SBK-L-10215

Seabrook Station
Emergency Response Manual, Revision 119 and Radiological Emergency Plan, Revision 59

Enclosure 1 to SBK-L-10215

Summary of Changes

FIGURE 1
OPERATIONAL SUPPORT CENTER (OSC) STAFF

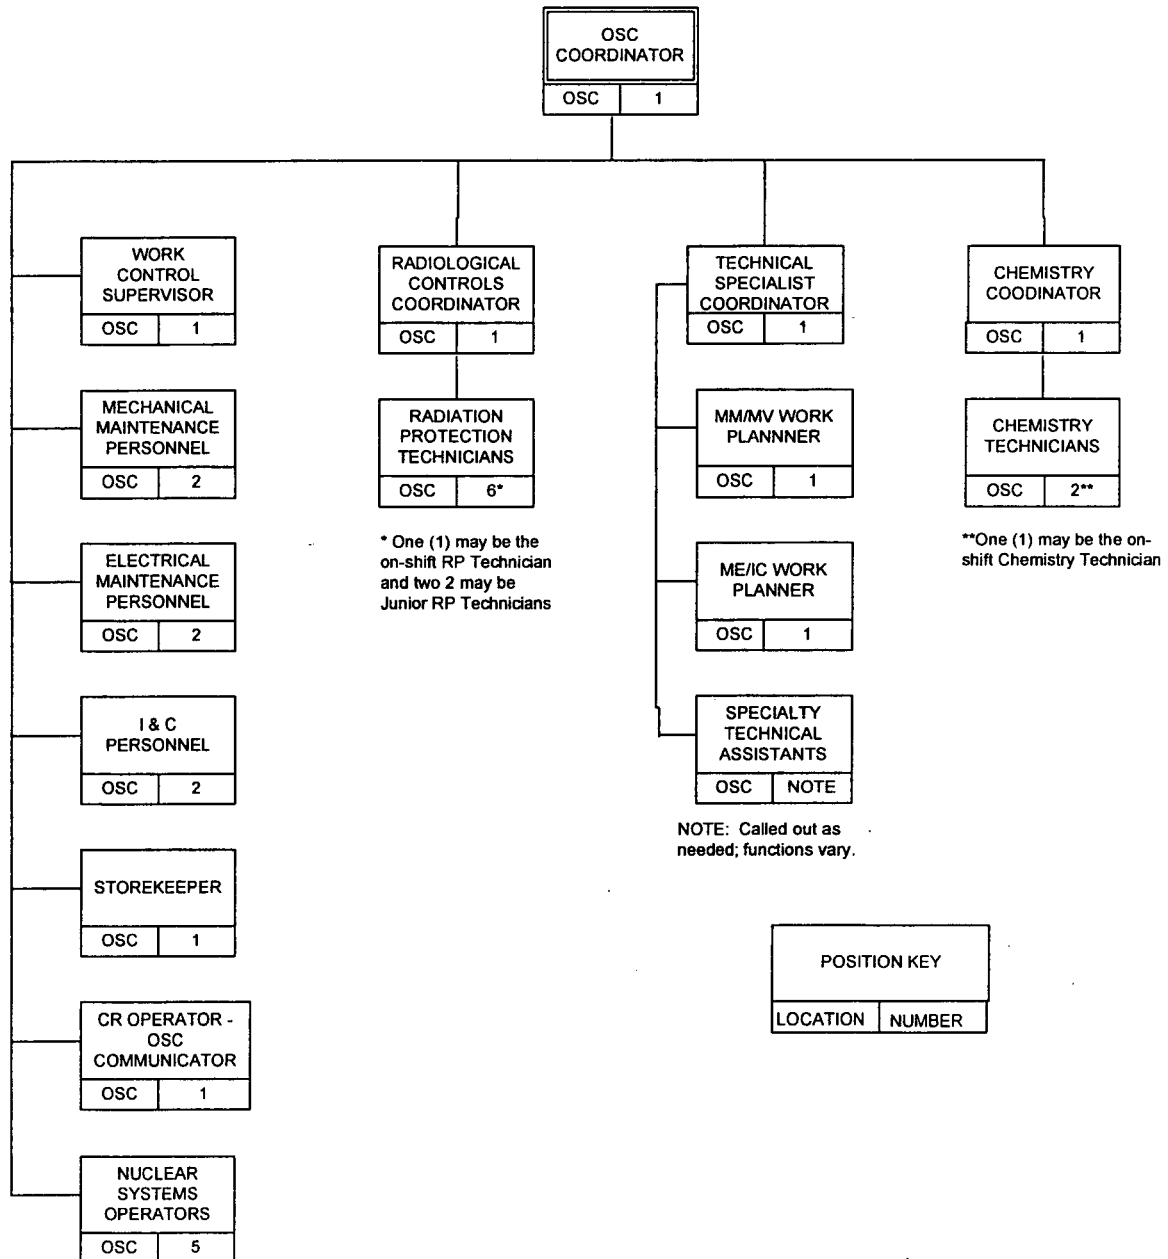
- On Figure 1, OSC Staffing Chart, added positions of Mechanical/Valve Maintenance Work Planner and Electrical Maintenance/I&C Work Planner. (AR#004611).

Figure 1
Raddose-V Start-Up Menu Screen
(Sheet 1 of 2)

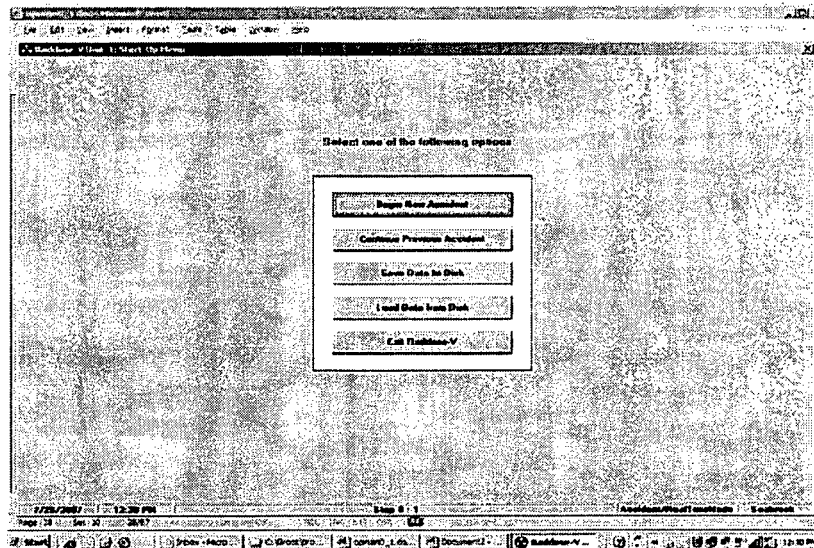
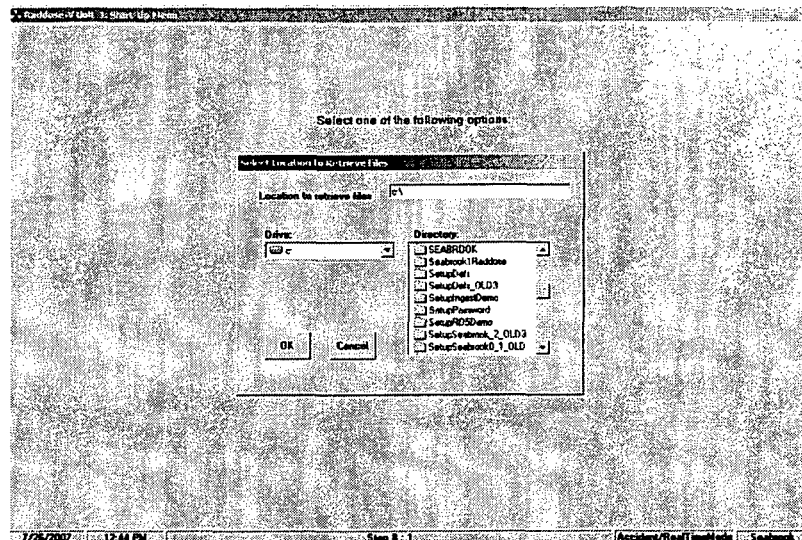
- On Figure 1, corrected reference to T drive to read P:/Saved Raddose Data. (AR#219941)
- On Figure 2, added instructions for using the GRAB sample method, incorporated flow rate for waste gas system fan and referenced the instructions in appropriate steps of forms ER 5.3A, 5.3B, 5.3C, 5.3D, 5.3E, 5.3F and 5.3G. (AR#571247)
